RE: 165-185 Glenwood Street- Development Option Plan

GLENWOOD GILL CONDOMINIUMS

DESIGN REVIEW COMMITTEE

REVISED 05.31.2023

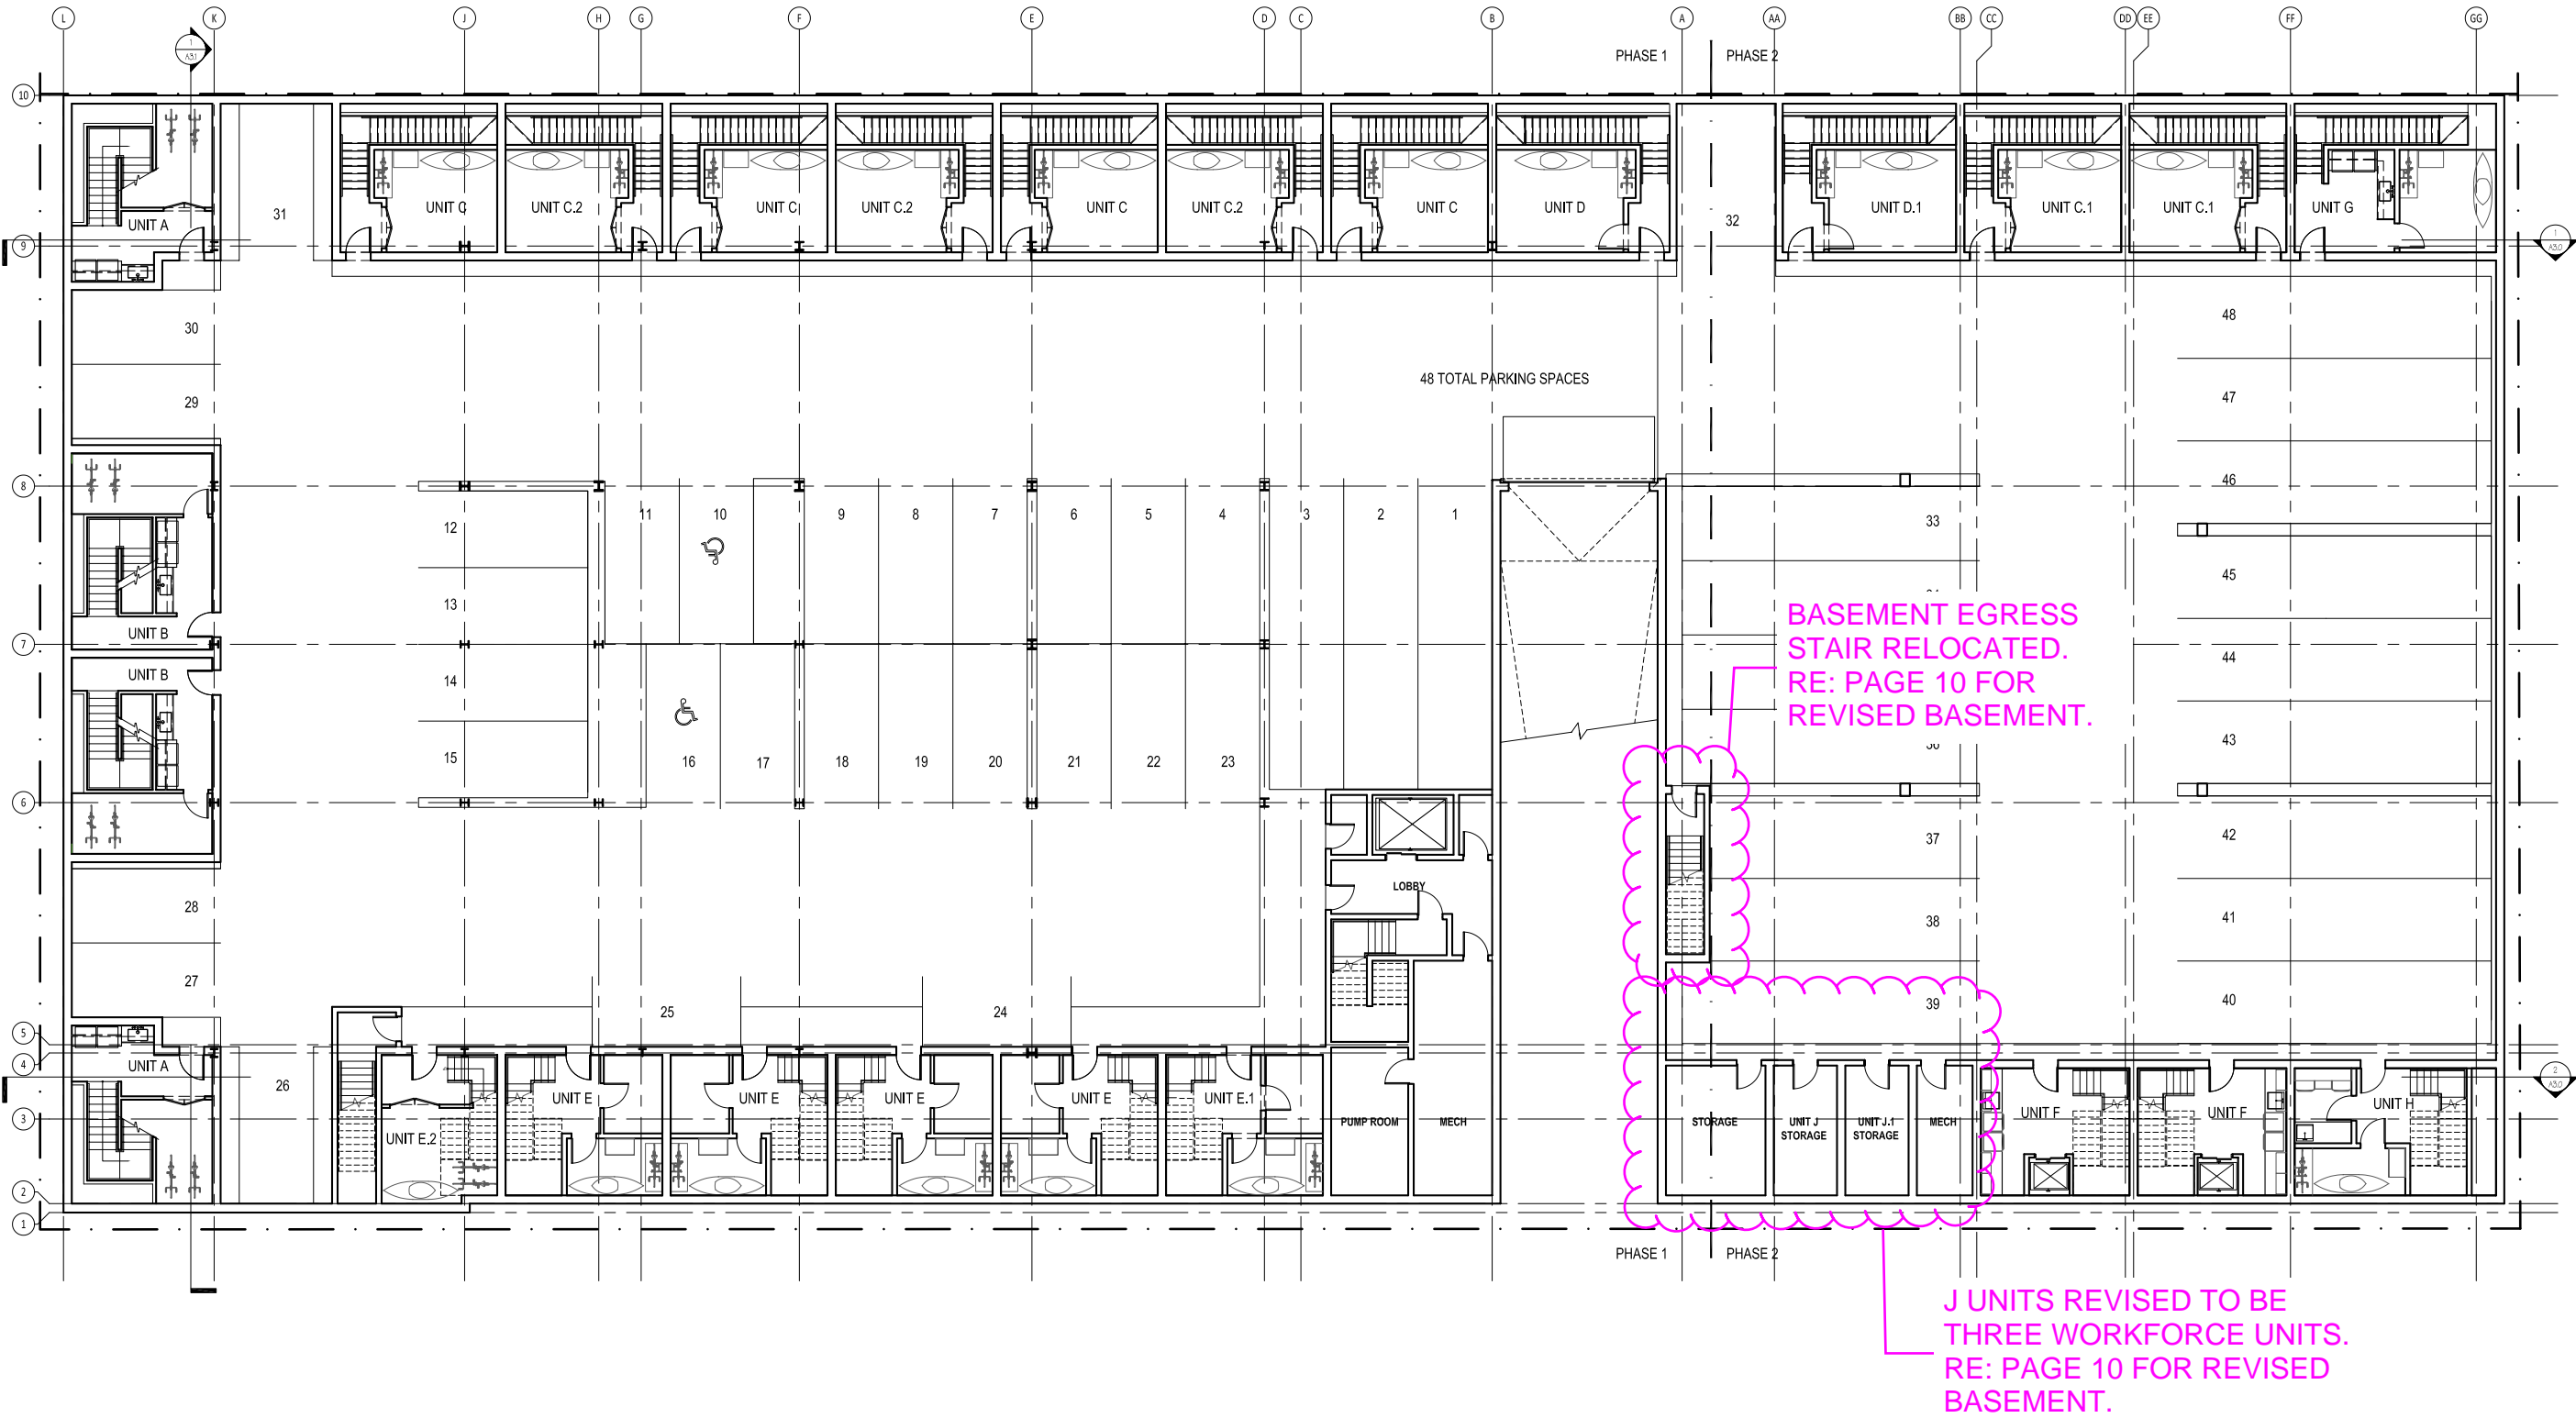
J UNITS REVISED TO BE
THREE WORKFORCE UNITS.
RE: PAGE 11 FOR REVISED
FIRST FLOOR PLAN

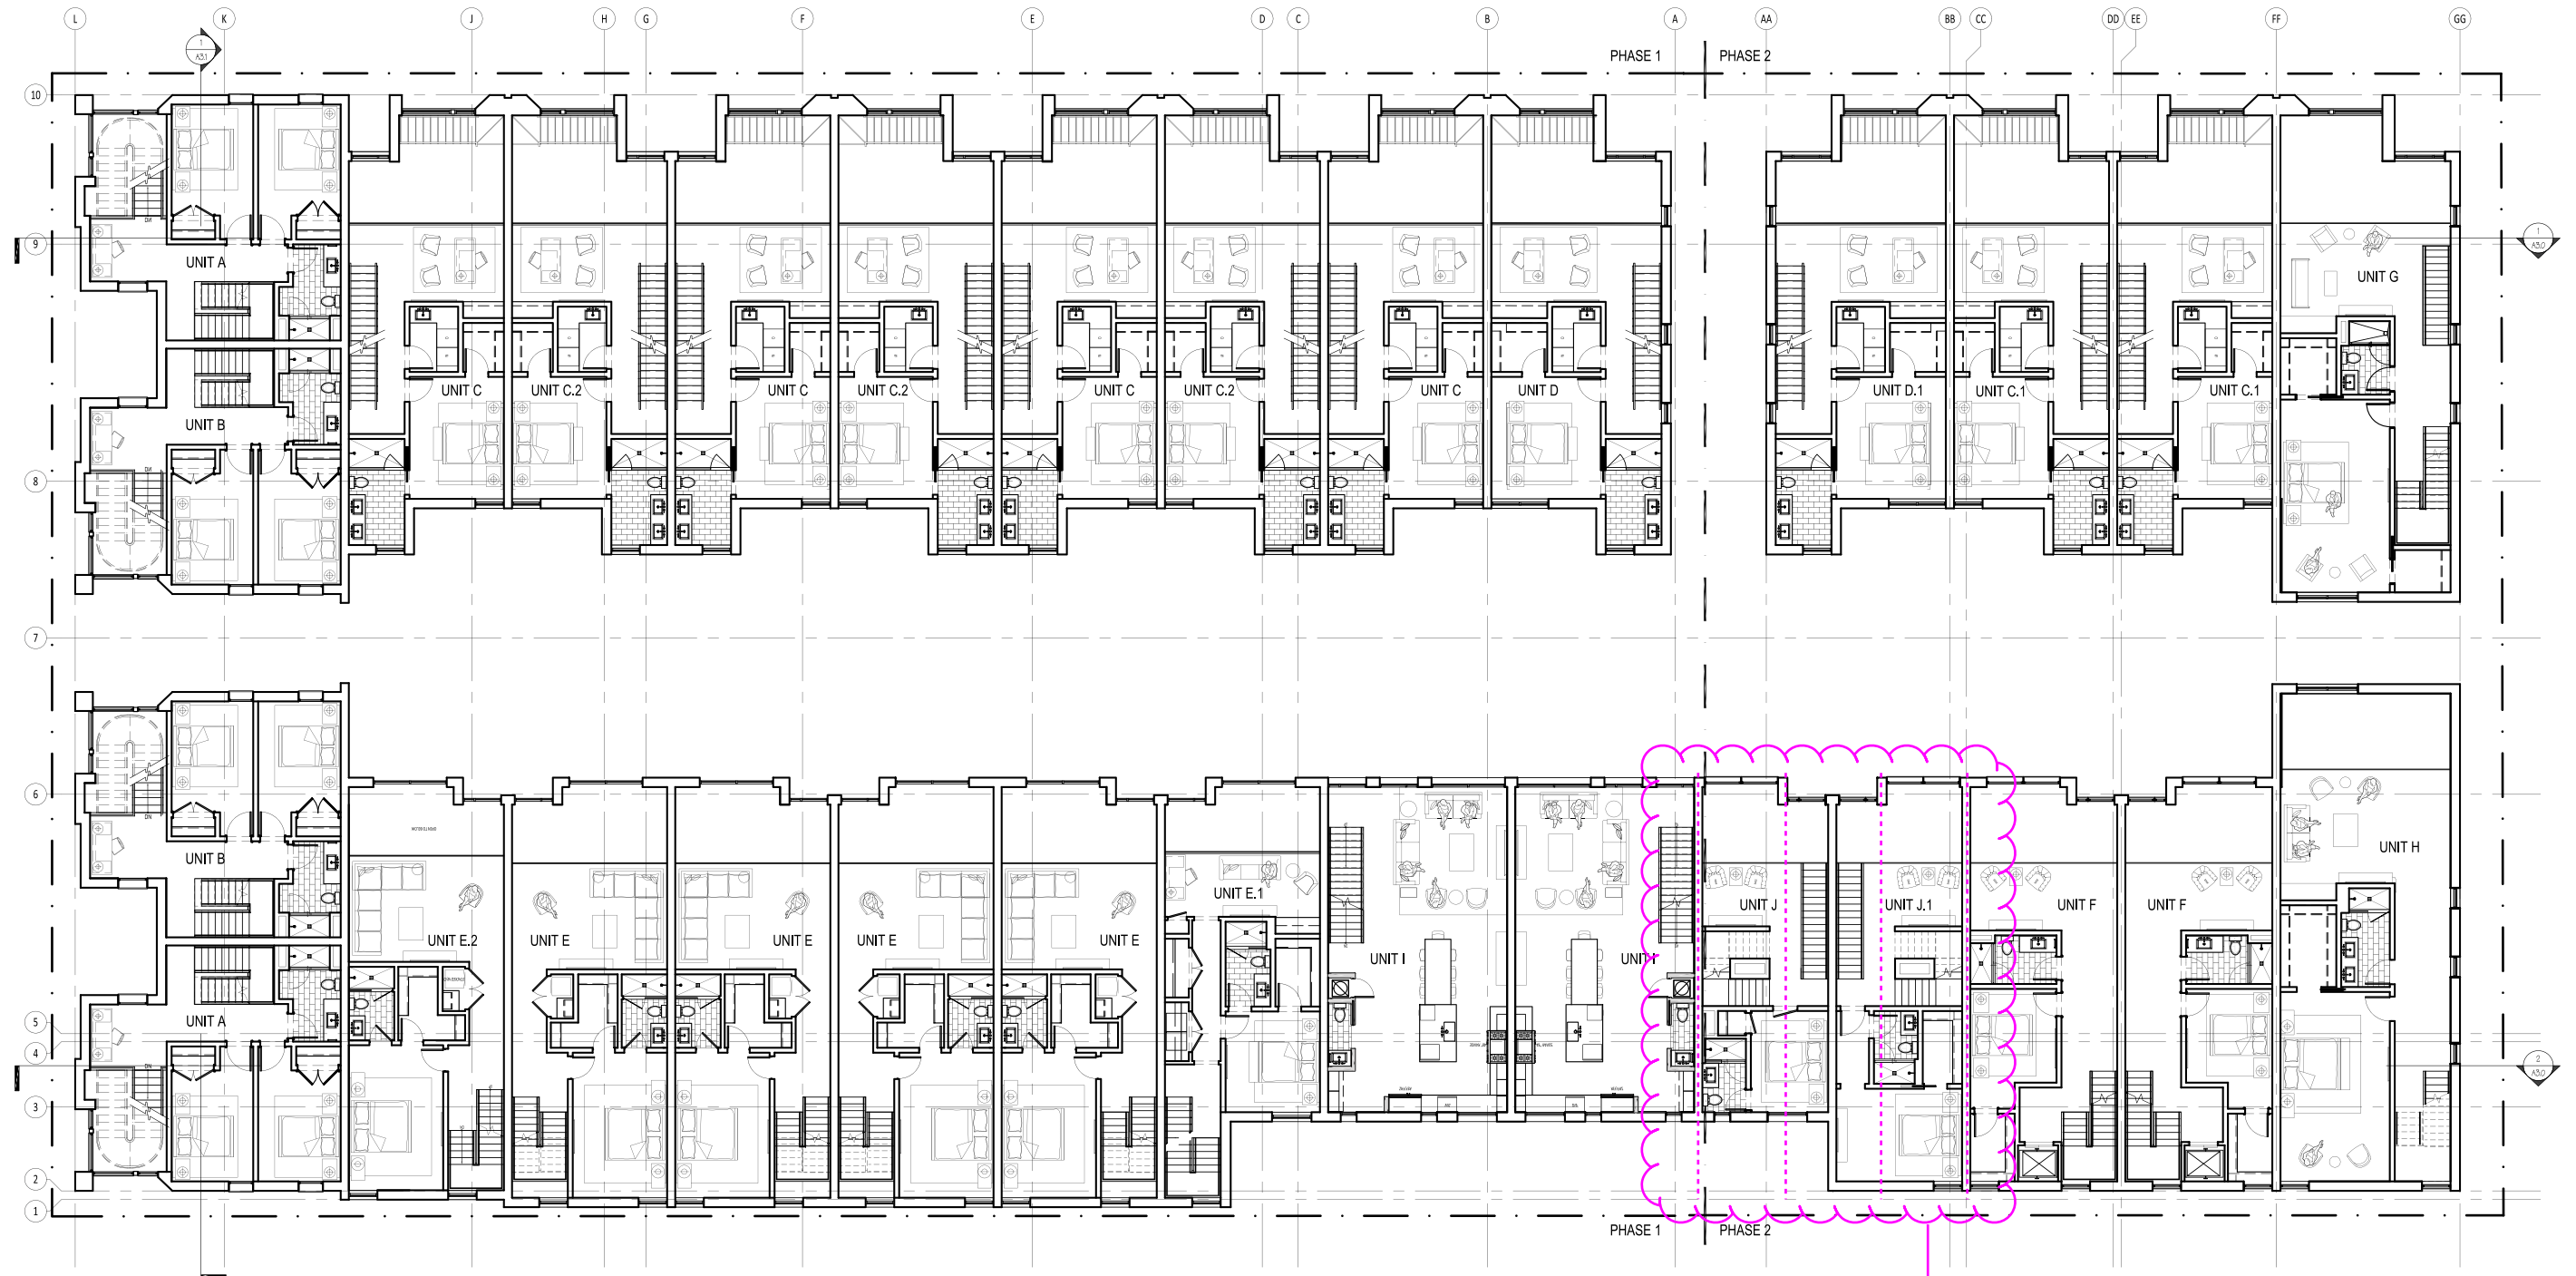
BASEMENT EGRESS STAIR
RELOCATED.
RE: PAGE 11 FOR REVISED
FIRST FLOOR PLAN.

J UNITS REVISED TO BE
THREE WORKFORCE UNITS.

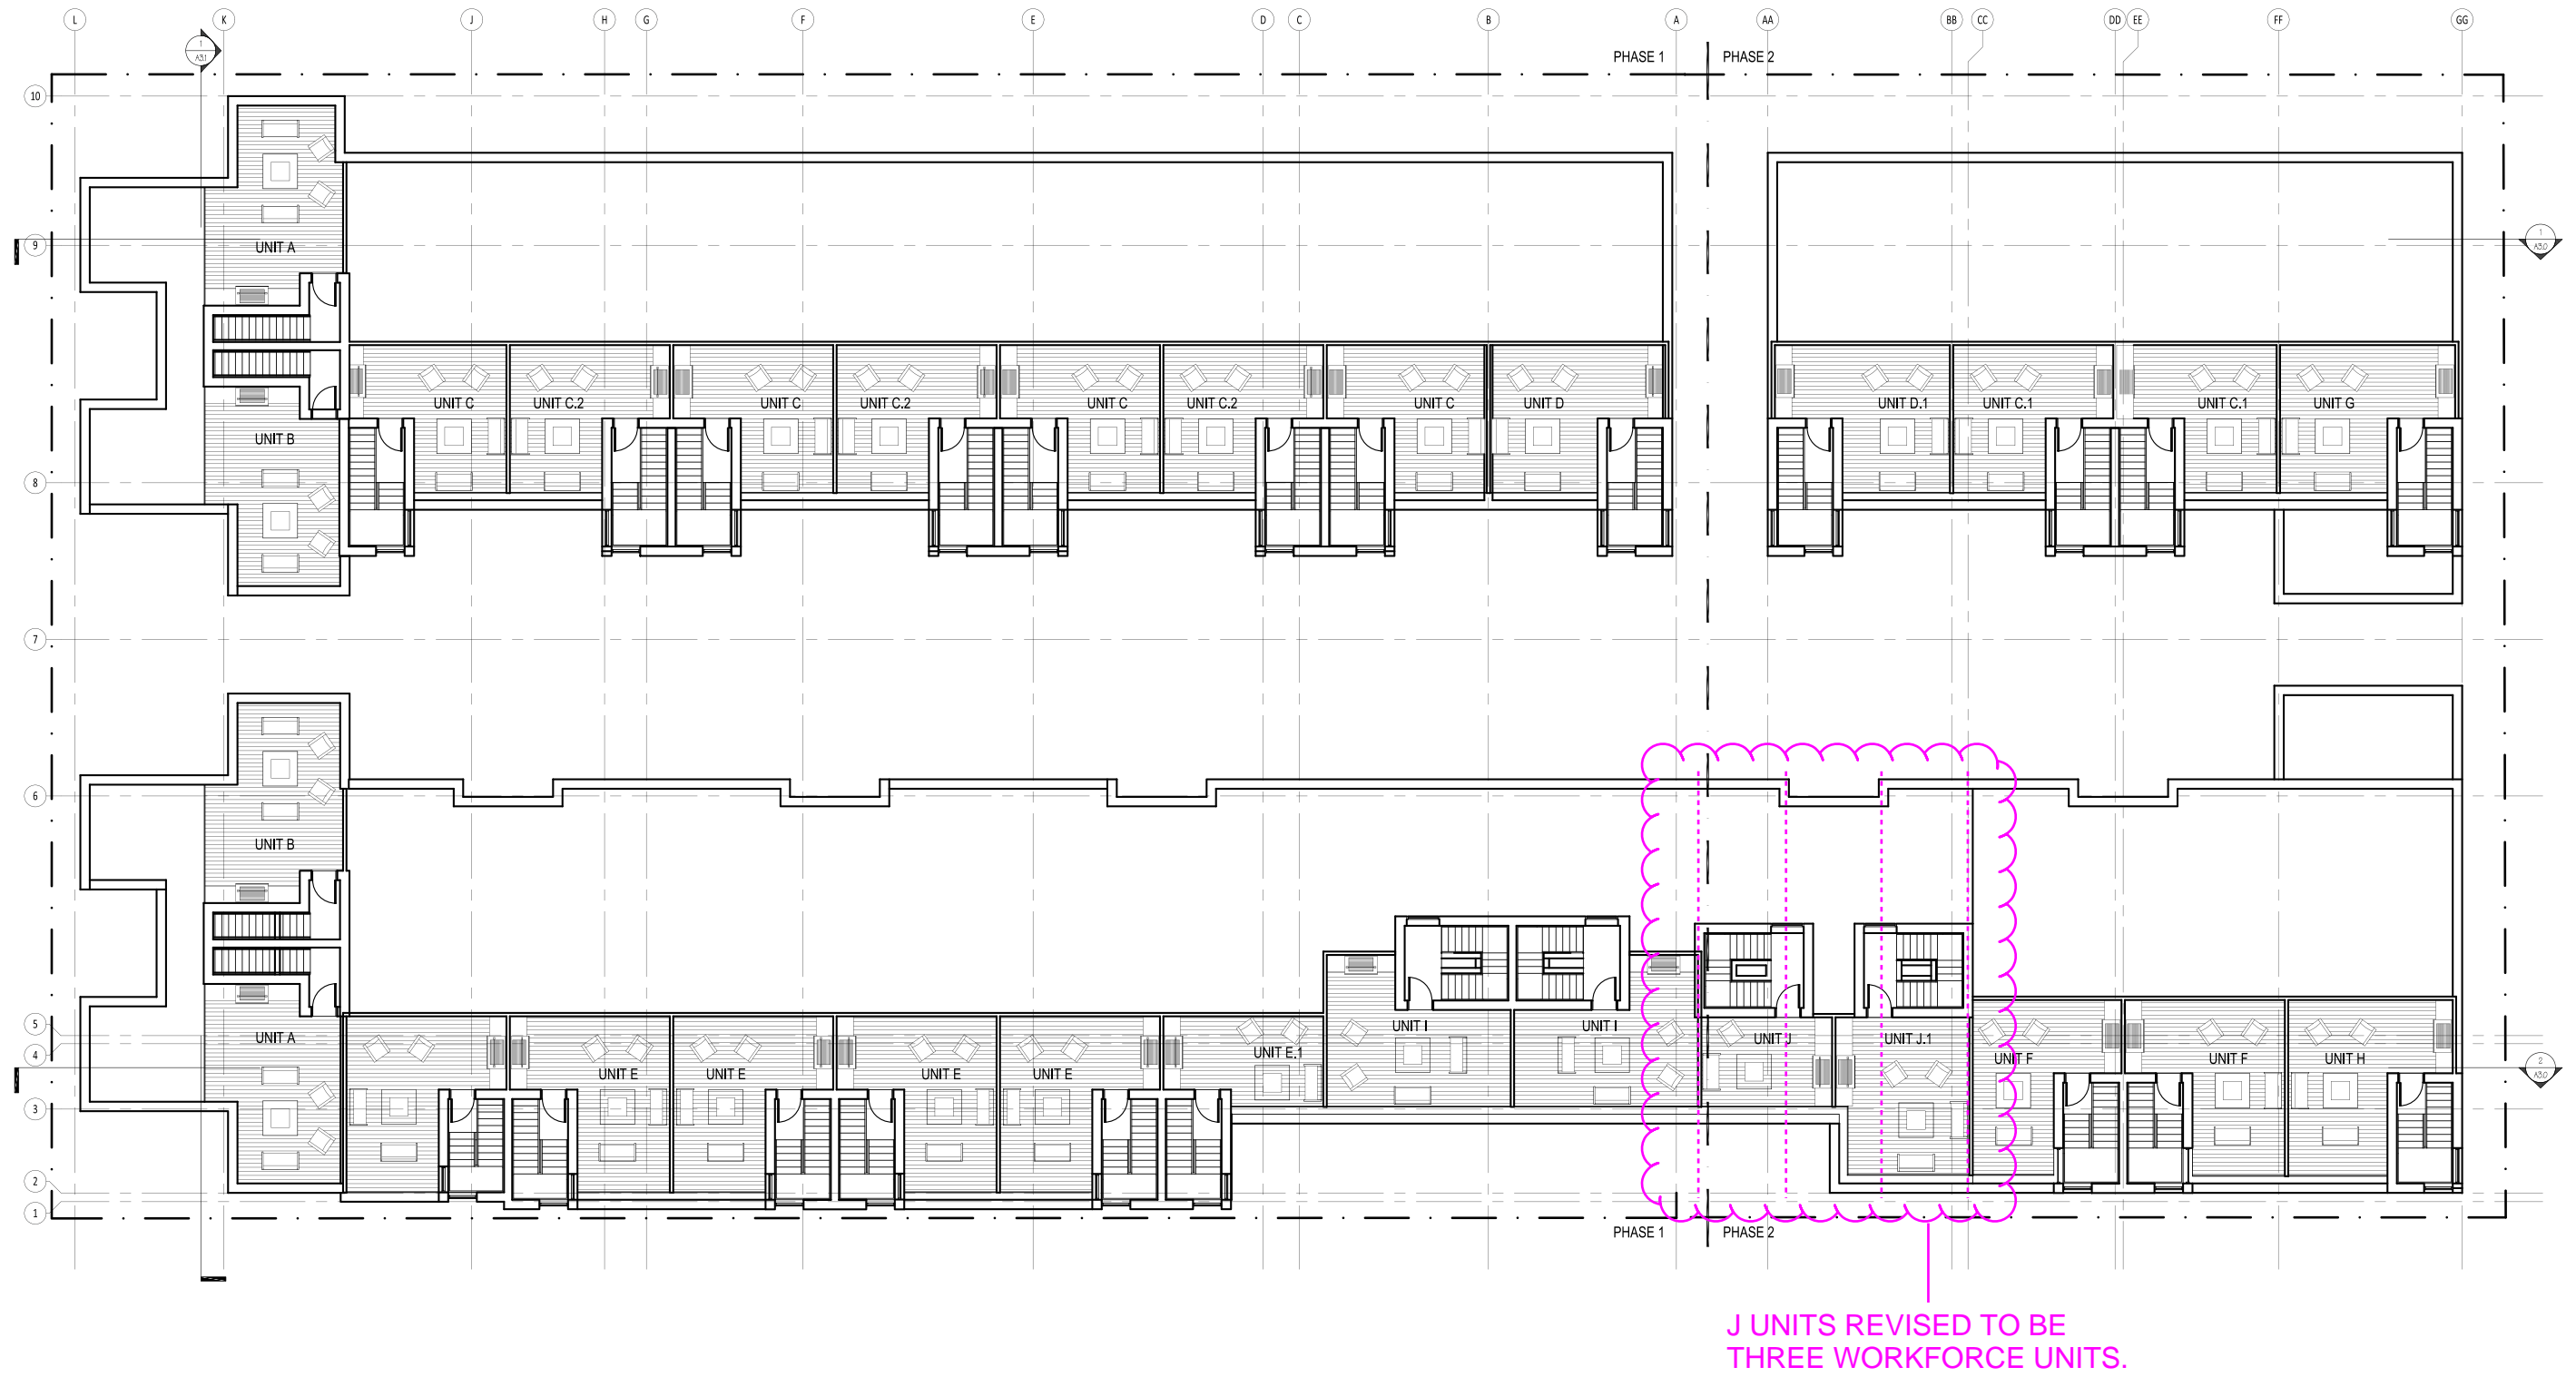
J UNITS REVISED TO BE
THREE WORKFORCE UNITS.

① EAST ELEVATION UNITS H,F,J
1/8" = 1'-0"

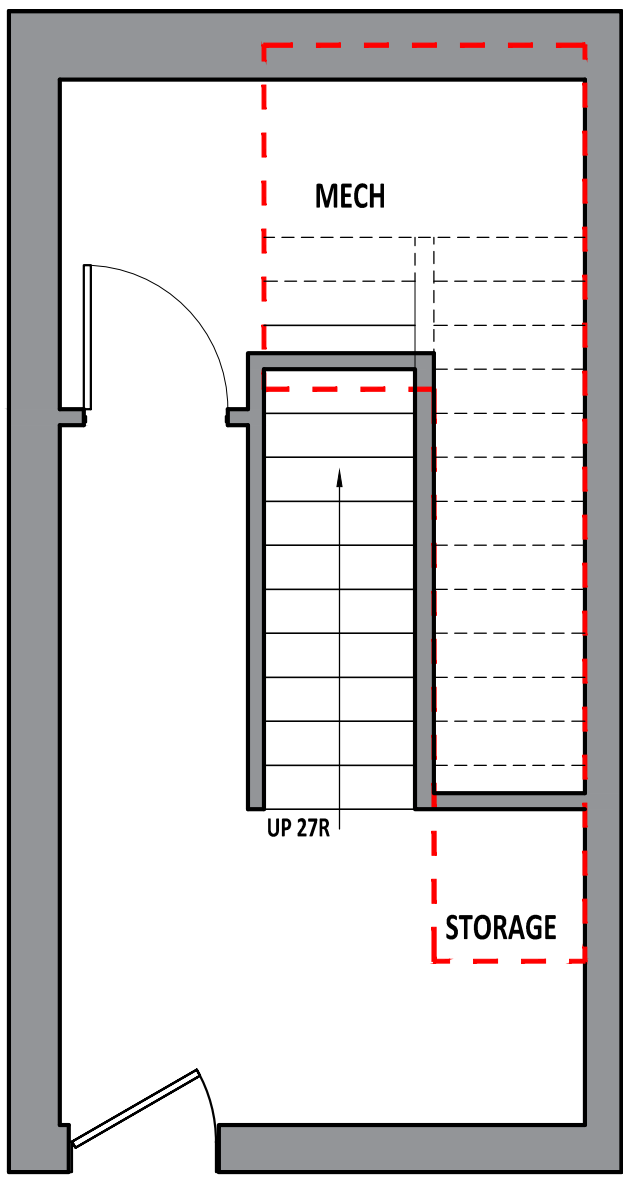
ROOF TOP STAIR ACCESS AND
PILOT HOUSE REMOVED.
RE: REVISED ELEVATION PAGE 15
